DEPARTMENT OF HIGHWAYS ONTARIO									
BRIDGE DIVISION									
UNDERPASS AT SHARPES LANE									
APPROX 2.7 MILES EAST OF HWY. NO. 29									
KING'S HIGHWAY No. 401					DIST. No. 8				
CO. LELDS					LIZABETH TOWN TWP. BRIDGE NO. 19				
TWP. LIZABETH TOWN					LOT 2 & 3		CON. I		
—GENERAL ARRANGEMENT—									
APPROVED					SITE No. 17/125		W.P. No. 76-59		
BRIDGE ENGINEER									
DESIGN	M. M.	CHECK	/	CONTRACT					
DRAWING	J. H. I.	CHECK	/	Nos.					
DATE	APRIL 1963	LOADING	1120 S LG	DRAWING		D-5037-1			
				No.

D.H.O. FOUNDATION INVESTIGATION
REPORT.
W.J. 62-F-4 -- W.P. 76-59.

Underpass at Sharpes Lane, 2.7 Miles East of
Hwy. #29, Hwy. #401, District #8 (Kingston).

We have reviewed the Bridge Dwg. D-5037-1, showing the general arrangements of the above-mentioned job, and submit the following comments:

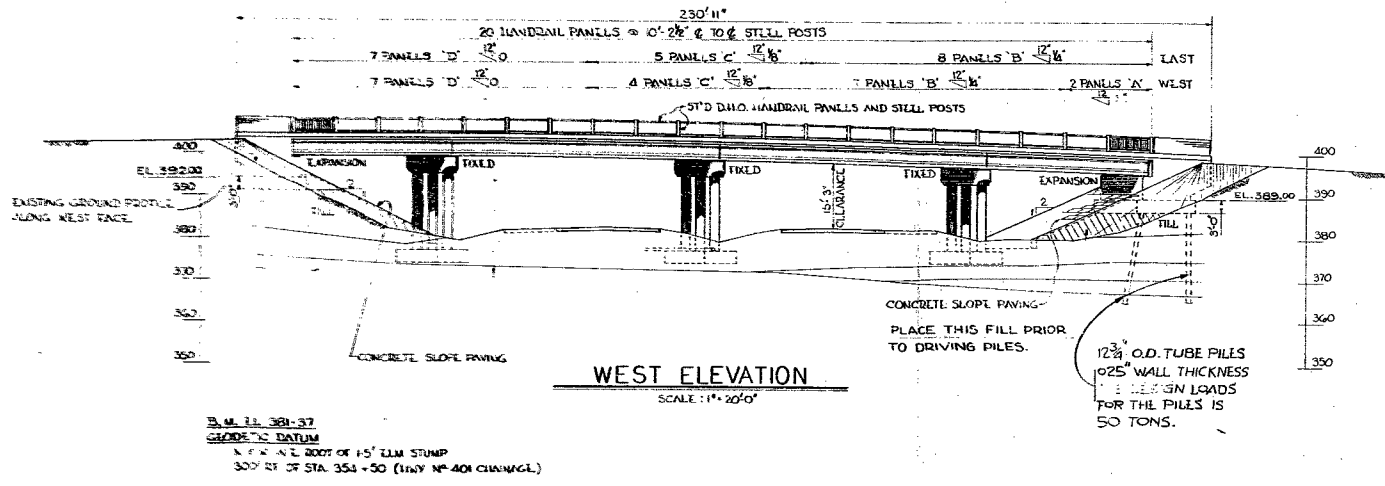
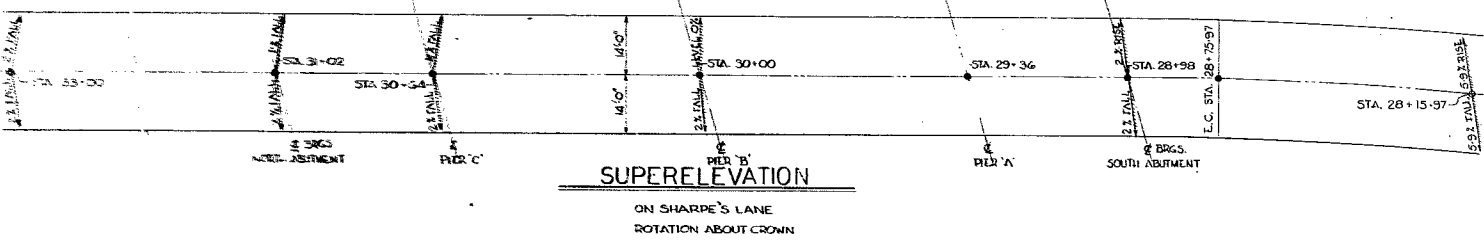
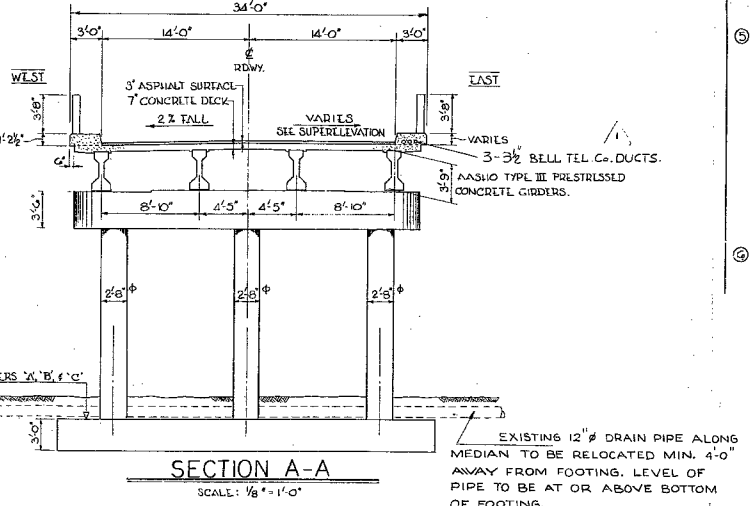
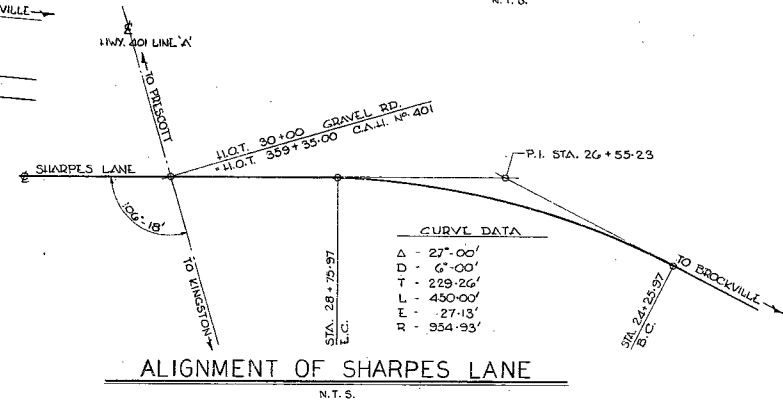
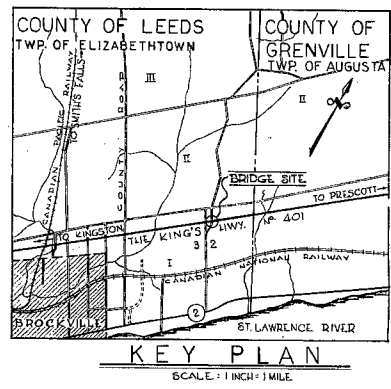
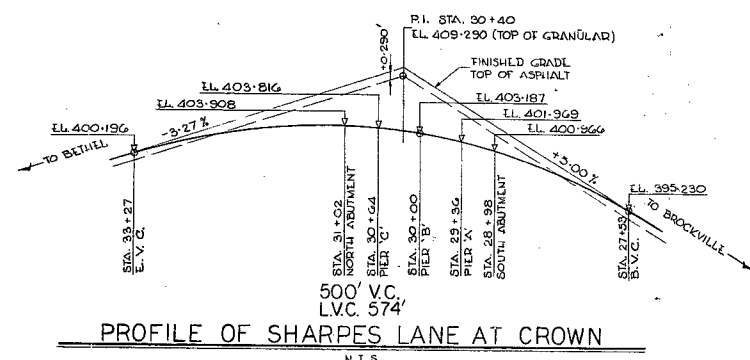
We have reviewed the Bridge Dwg. D-5037-1, showing the general arrangements of the above-mentioned job, and submit the following comments:

1) The tip elevations for the piles supporting the perched abutments are not defined on the bridge drawing.

2) In our Foundation Report, we recommended that tip elevation for the above-mentioned piles be about Elev. 375; however, these piles, during driving, should be controlled by the use of the Hiley formula according to current D.H.S. Standards DD 1217 & DD 1218.
